CHRYSLER A604 (41TE) UPDATE HANDBOOK

**AUTOMATIC TRANSMISSION SERVICE GROUP
9200 S. DADELAND BLVD. SUITE 720
MIAMI, FLORIDA 33156
(305) 670-4161**

"UPDATE HANDBOOK"

Figure 38

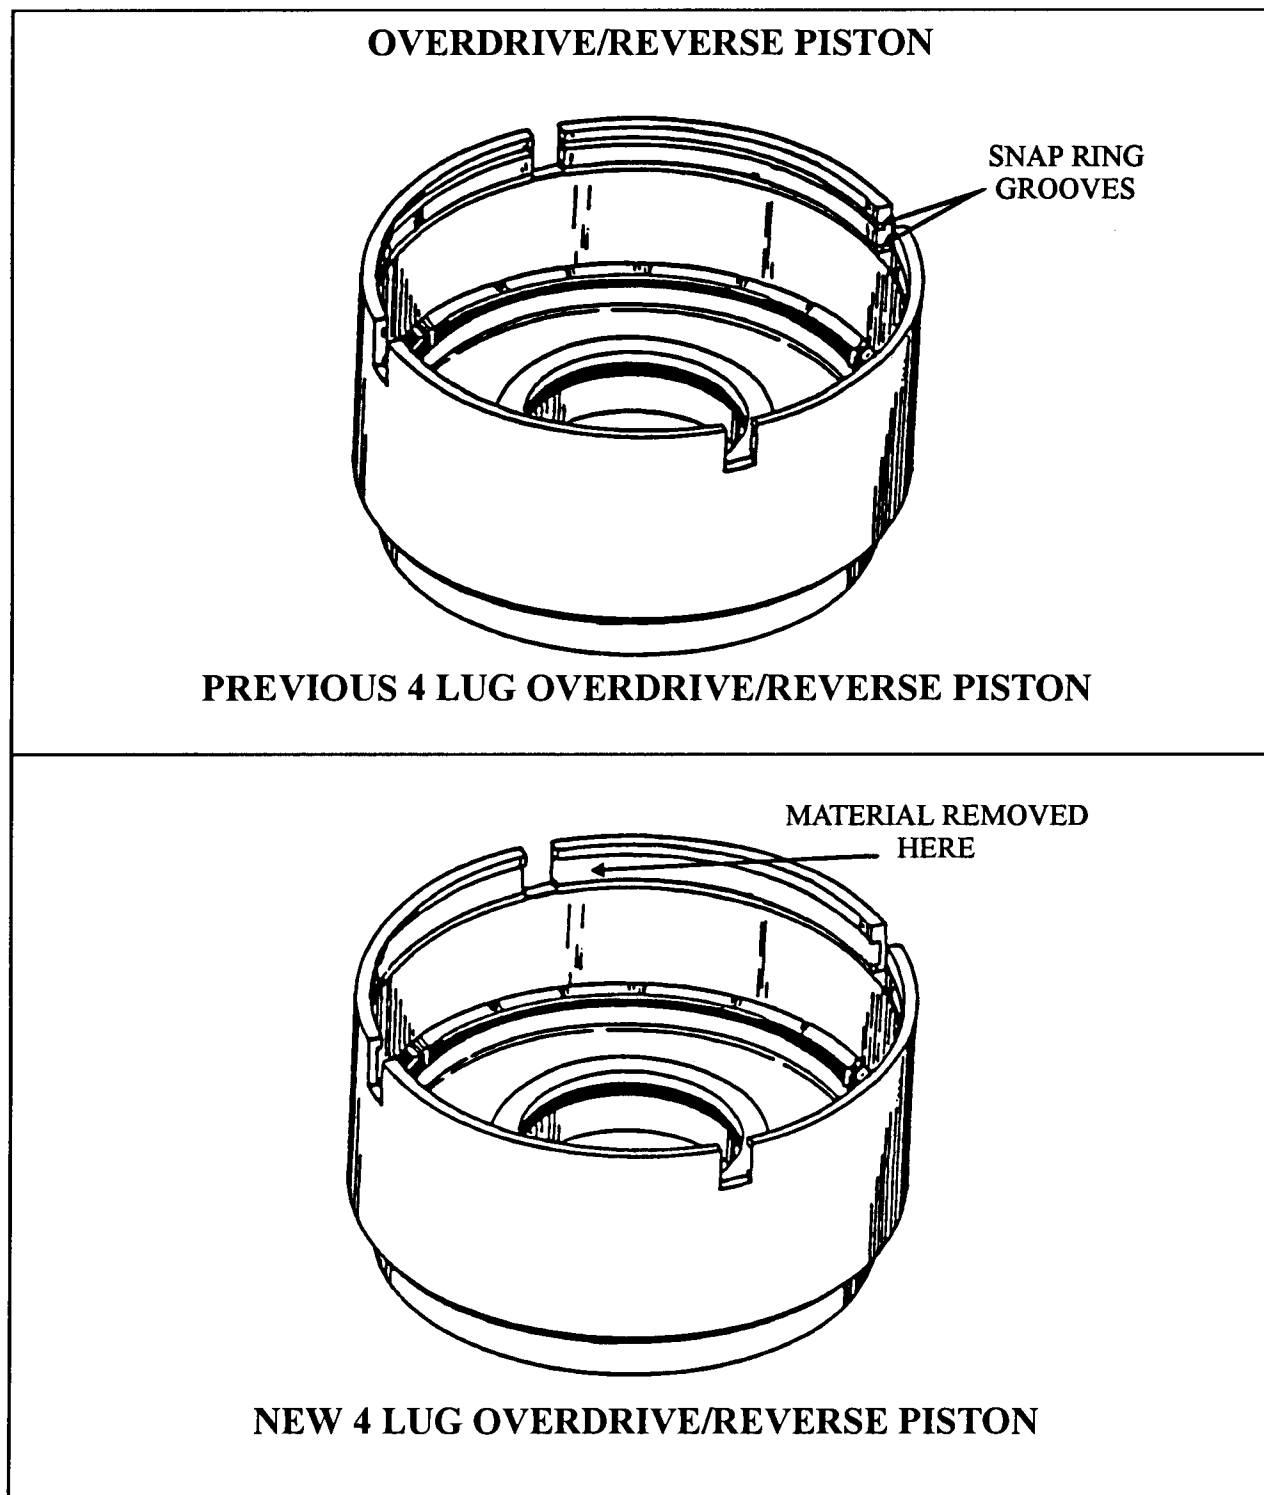
CHANGE: A 1991 running change was made to the overdrive/reverse piston, eliminating the material between the two snap ring grooves (See Figure 38).

REASON: To prevent the possibility of the overdrive/reverse reaction plate from binding in the overdrive/reverse drum, since it is also piloted on the outside diameter (See Figure 38).

- (1) **OVERDRIVE/REVERSE PISTON** - The drum material between the previous two snap ring grooves has been eliminated, as the Overdrive/Reverse Reaction Plate is also piloted on the outside diameter (See Figure 38). The snap ring and plate "Stack-Up" is **EXACTLY** the same as previous models with the new design level piston.

Figure 39

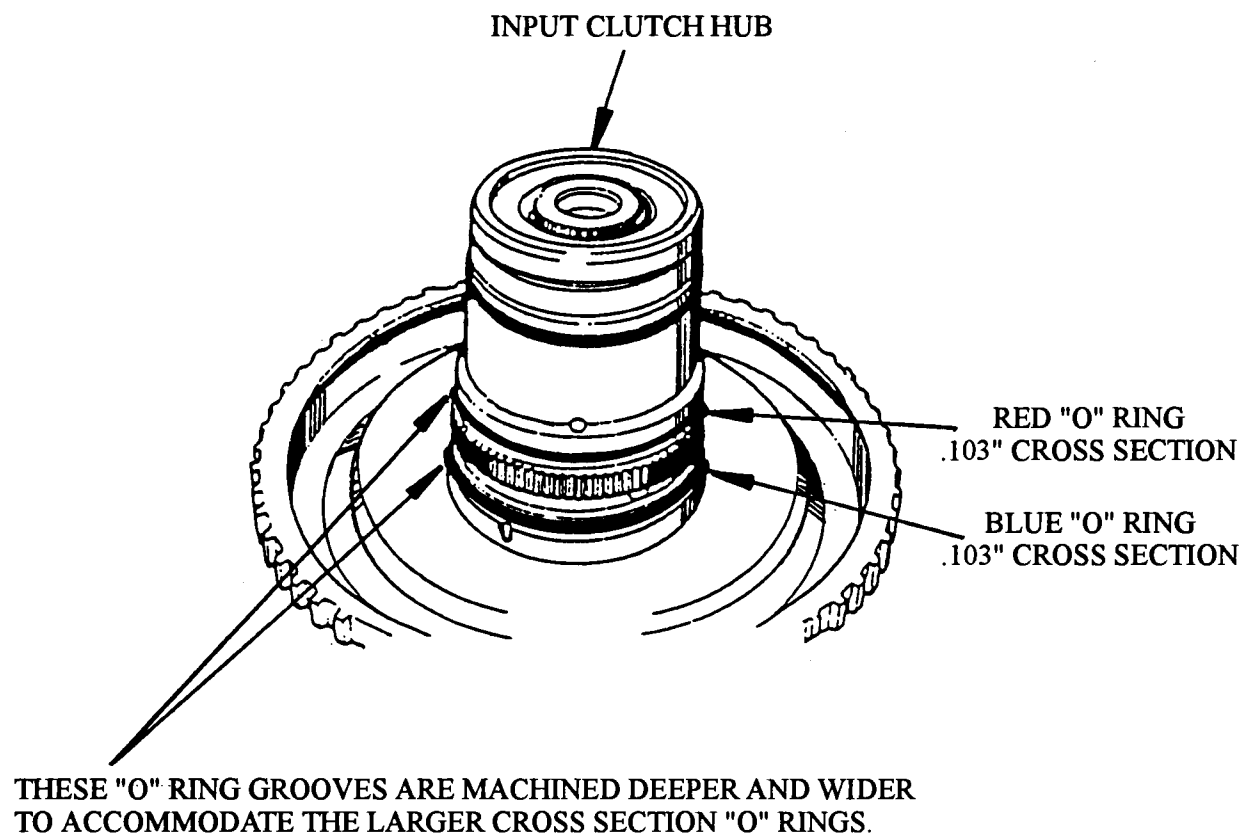
- (1) **INPUT CLUTCH HUB** - The "O" ring grooves on the Input Clutch Hub are cut deeper and wider to accommodate the larger cross section color coded "O" rings (See Figure 39).

Figure 43

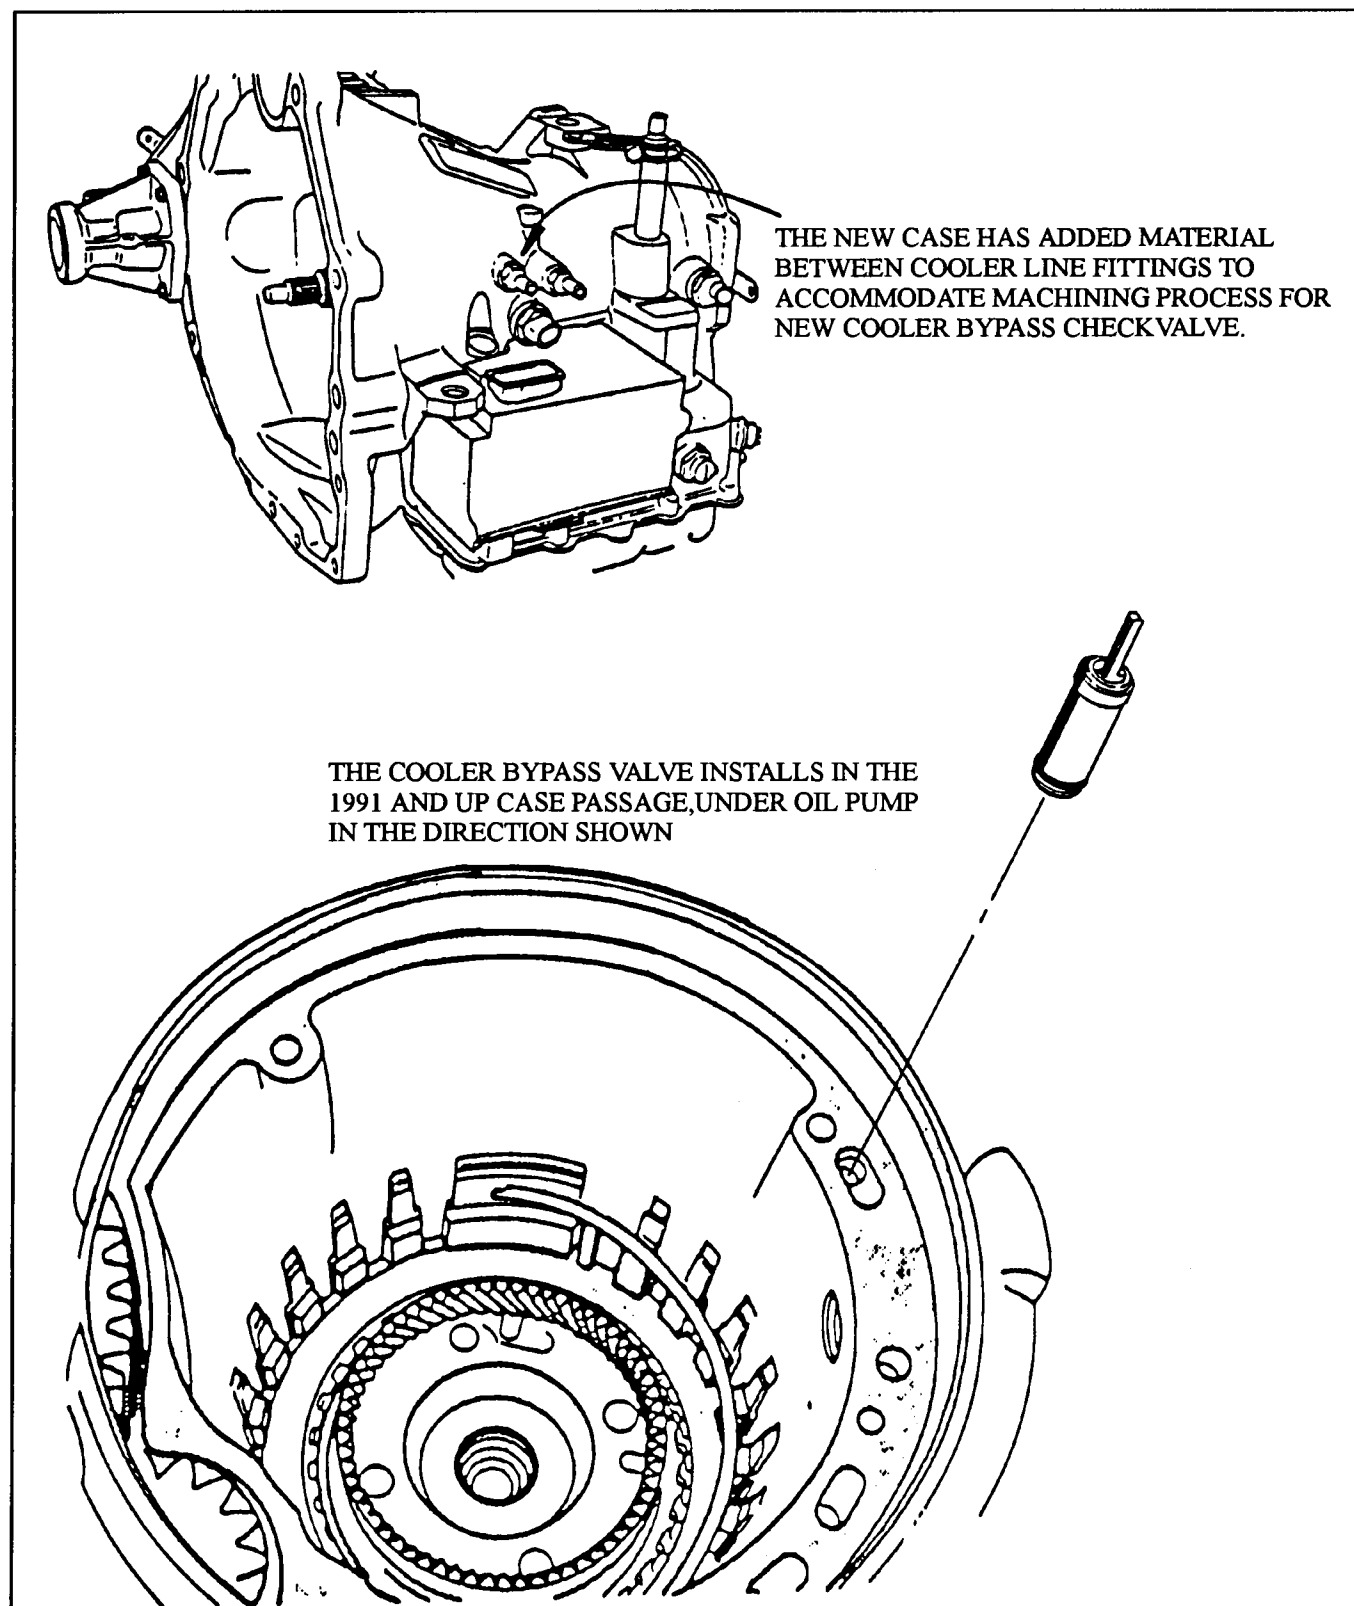
CHANGE: Beginning in 1991 model A604 transaxles, there has been a "Cooler Bypass Check Valve Assembly" added in the transaxle case behind the oil pump. (See Figures 42 and 43).

- (1) **COOLER BYPASS CHECK VALVE** - added into the case cooler passage behind the oil pump (See Figure 43). If cooler oil flow is restricted, or blocked, the new check valve will open, and allow cooler feed oil direct into the lube circuit to prevent transaxle damage. Normal operation is resumed after oil temperature is warm enough to again flow through the cooler. (See Figure 42).
NOTE: Customers should be advised to let the vehicle warm-up thoroughly before attempting to drive the vehicle, especially in the colder climates.
- (2) **TRANSAXLE CASE** - The new case has added material between the two cooler line fittings, to accommodate the machining process needed for the new cooler bypass check valve assembly (See Figure 43).
- (3) **VALVE BODY SPACER PLATE** - Lube feed hole in spacer plate has been enlarged to .112", as shown in Figure 44.

Cooler bypass check valve assembly "WILL NOT" retrofit back to previous models, unless the new transaxle case is installed at the same time. The lube feed hole in the spacer plate can be drilled to .112" on all models to improve lube oil flow (See Figure 44).

Figure 60

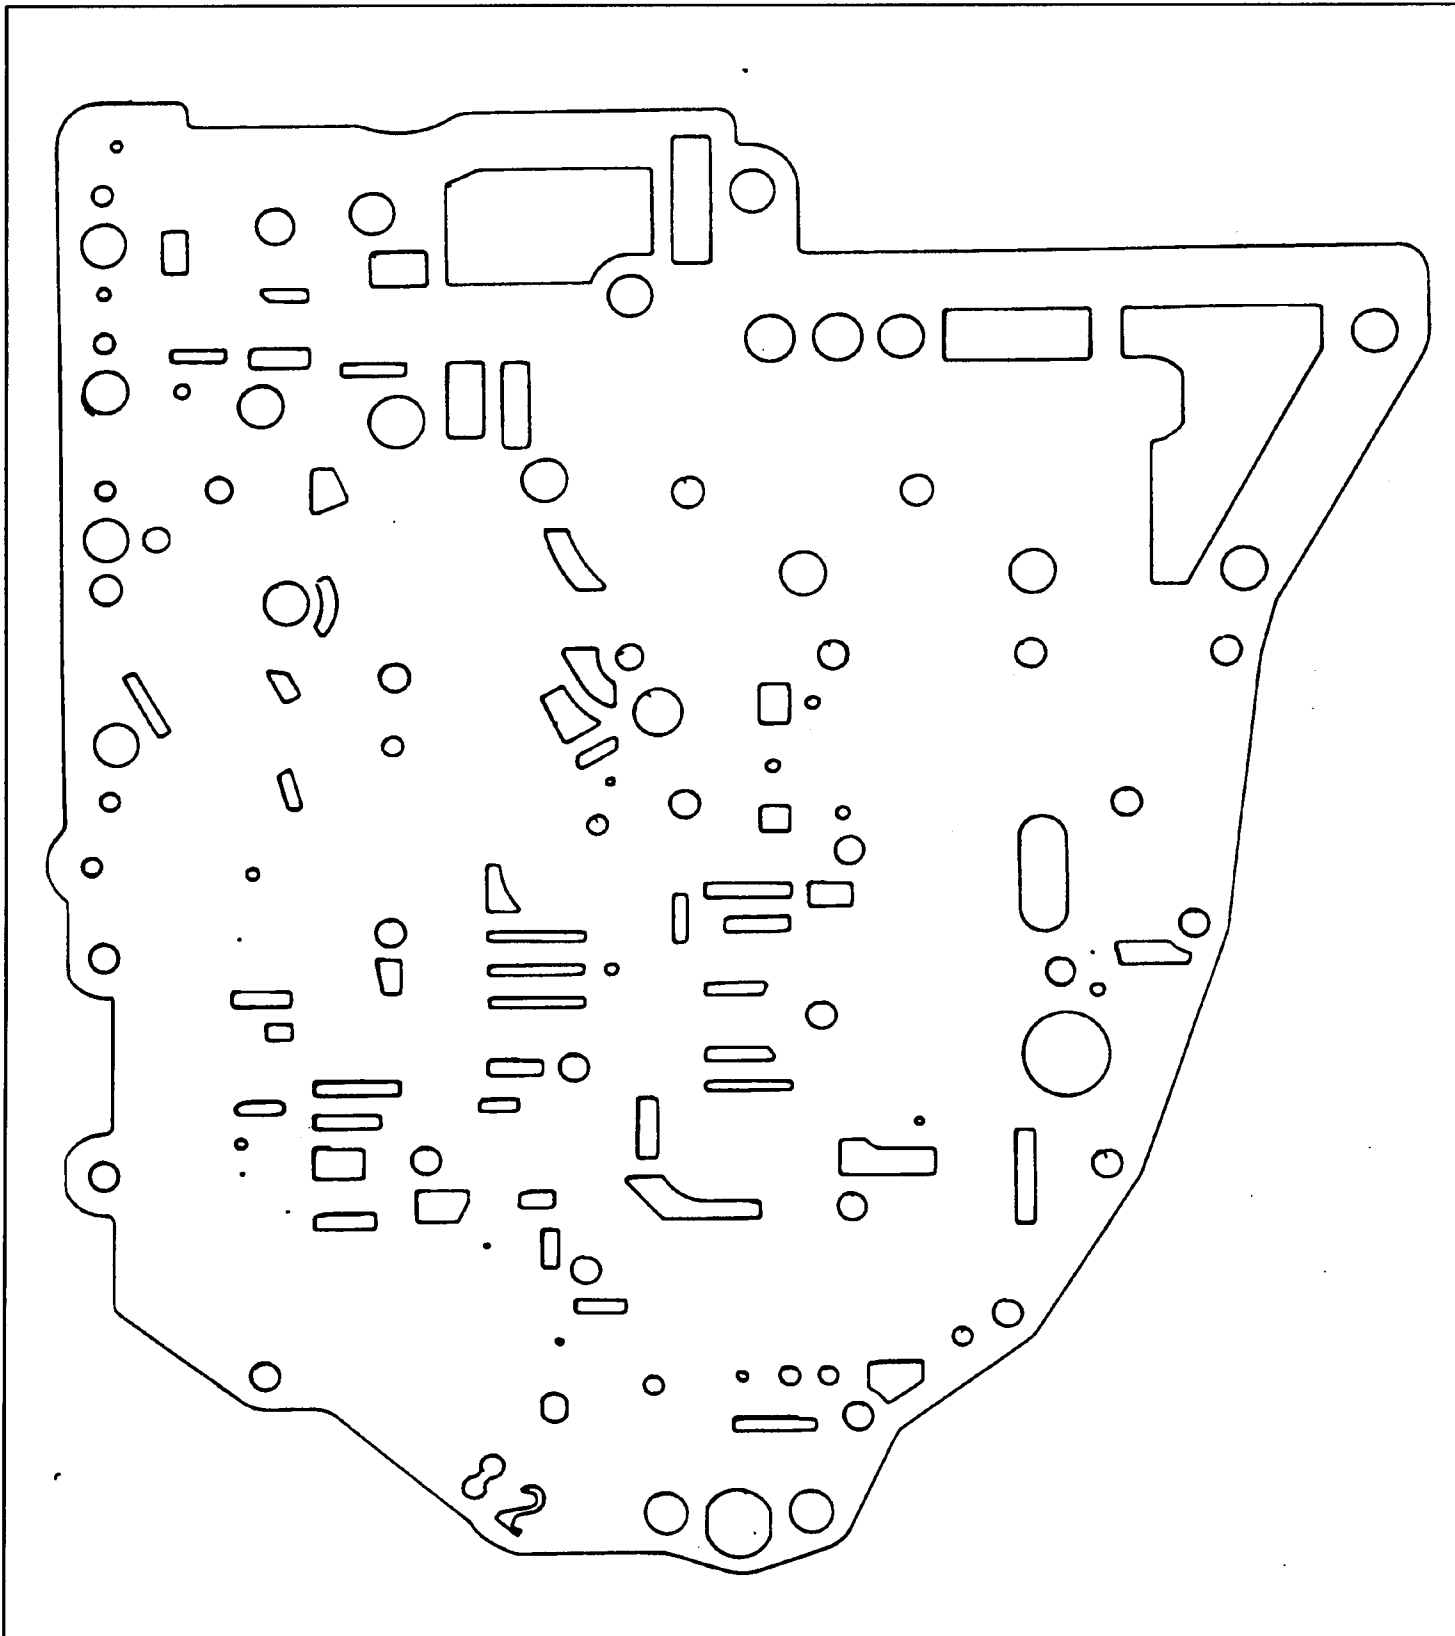
CHANGE : A running change in 1994 was made to the spacer plate (See Figure 60) and to the Pressure Regulator Valve (See Figure 61).

Figure 62

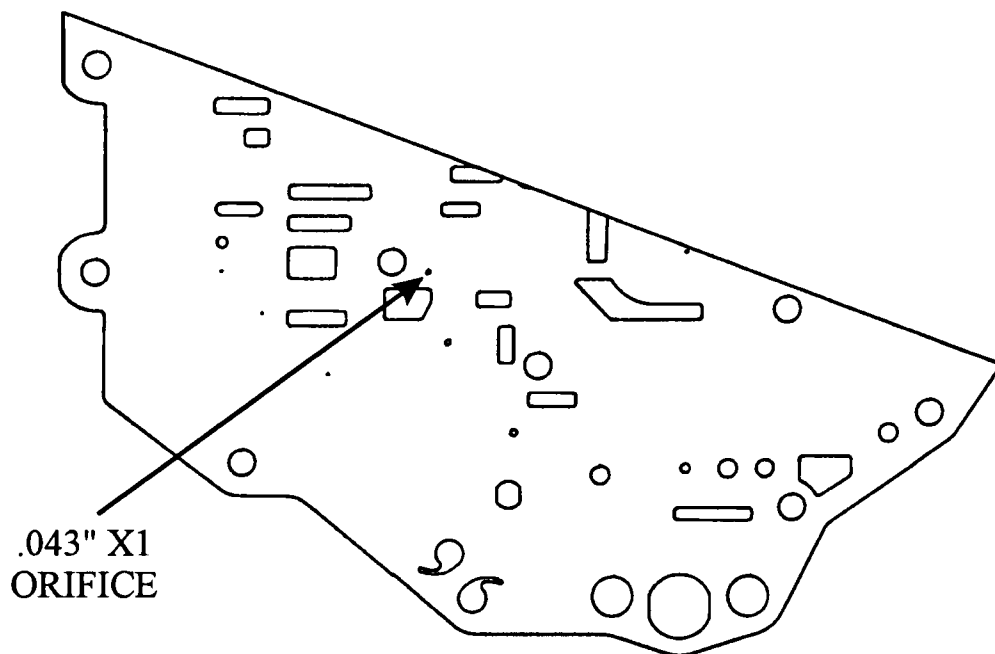
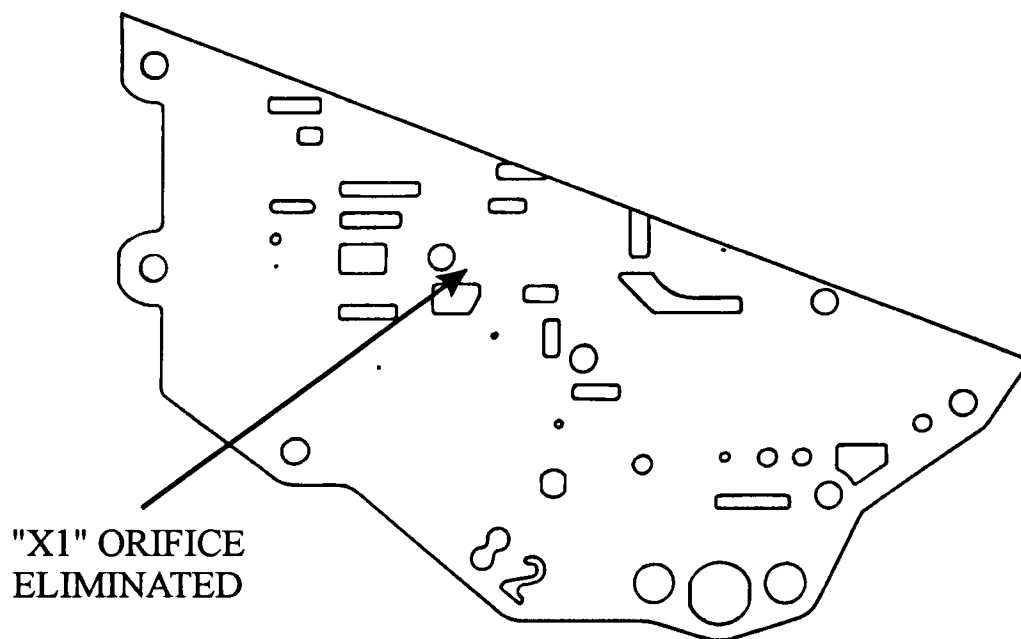
- (1) : **SPACER PLATE:** The "X1 Orifice" in the spacer plate has been eliminated as shown in figure 62. The plate can be easily identified by the number "82" that is punched through the plate (See Figure 62).
- (2) : **PRESSURE REGULATOR VALVE:** A ground step has been machined to the inner land on the Pressure Regulator Valve causing two different diameters to exist on one land (See Figure 63). There are no obvious or visible signs or identification marks to indicate the updated Pressure Regulator Valve. Careful measurement of the valve land is needed to properly identify the valve (See Figure 63). The spring side of the land measures approximately .6255". The opposite end of the same land will measure approximately .6245" (See Figure 63).

The new "82" spacer plate replaces the previous "96" spacer plate and can retrofit back to all valve bodies and Transfer Plates that use the # 96 spacer plate **provided that the new pressure regulator valve is used together with the # 82 spacer plate.** Valve bodies that use a 96 spacer plate has a casting number of 4511644 (See Figure 52 on Page 68). Transfer Plates that use the # 96 spacer plate has a casting number of 4511645 (See Figure 54 on Page 70).

Figure 65

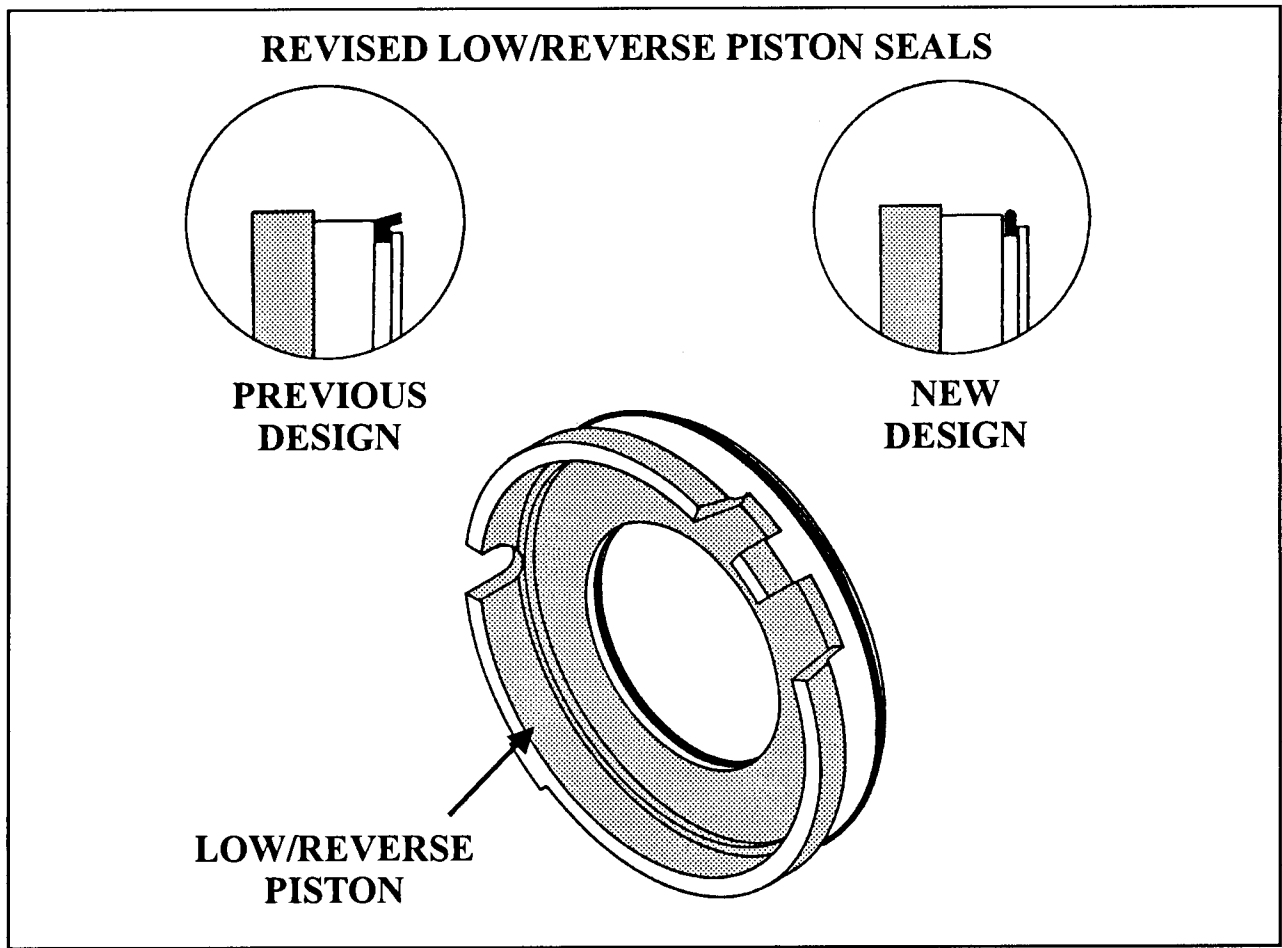
CHANGE: Beginning at the start of production for 1995 model year, all Chrysler A604 (41TE) and A606 (42LE) transaxles were produced using revised seals for the Low/Reverse piston. The previous "Lip" type seals have been replaced by a "D" Ring type seal for both inner and outer seals, as shown in Figure 65.

- (1) **LOW/REVERSE PISTON SEALS** - Both the inner and outer lip seals have been replaced by a "D" Ring type seal, as shown in Figure 65. There were no dimensional changes necessary to the Low/Reverse piston to accommodate the new "D" Ring seals. The seals are available under OEM part number 4659185 for the outer seal, and 4659184 for the inner seal.
